TVA-SQN-TS-03-12

**SEQUOYAH NUCLEAR PLANT (SQN) UNITS 1 AND 2 TECHNICAL SPECIFICATIONS (TS) CHANGE 03-12, APPLICATION FOR TECHNICAL SPECIFICATION IMPROVEMENT TO EXTEND THE COMPLETION TIME FOR ACTION A OF TECHNICAL SPECIFICATION 3/4.5.1, 'ACCUMULATORS,' USING THE CONSOLIDATED LINE ITEM IMPROVEMENT PROCESS (CLIIP)**

Proposed Technical Specification Changes (mark-up)

3/4.5.1 ACCUMULATORS

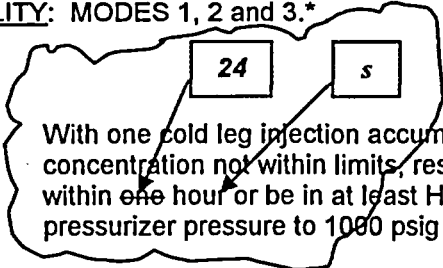
- a.  With one cold leg injection accumulator inoperable, except as a result of boron concentration not within limits, restore the inoperable accumulator to OPERABLE status within one hour or be in at least HOT STANDBY within the next 6 hours and reduce pressurizer pressure to 1000 psig or less within the following 6 hours.
- b. With one cold leg injection accumulator inoperable due to the boron concentration not within limits, restore boron concentration to within limits within 72 hours or be in at least HOT STANDBY within the next 6 hours and reduce pressurizer pressure to 1000 psig or less within the following 6 hours.

The proposed amendment would extend the completion time from 1 hour to 24 hours for "Action a" of TS 3/4.5.1, "Accumulators." The change is consistent with Nuclear Regulatory Commission approved Industry/Technical Specification Task Force (TSTF) Standard Technical Specification Change Traveler, TSTF-370, "Risk Informed Evaluation of an Extension to Accumulator Completion Times for Westinghouse Plants." The availability of this TS improvement was announced in the *Federal Register* on March 12, 2003, as part of the CLIIP.

#### 3/4.5.1 ACCUMULATORS

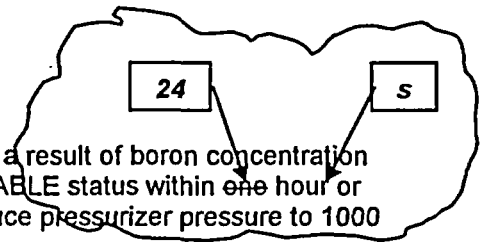
- a. With one cold leg injection accumulator inoperable, except as a result of boron concentration not within limits, restore the inoperable accumulator to OPERABLE status within one hour or be in at least HOT STANDBY within the next 6 hours and reduce pressurizer pressure to 1000 psig or less within the following 6 hours.
- b. With one cold leg injection accumulator inoperable due to the boron concentration not within limits, restore boron concentration to within limits within 72 hours or be in at least HOT STANDBY within the next 6 hours and reduce pressurizer pressure to 1000 psig or less within the following 6 hours.
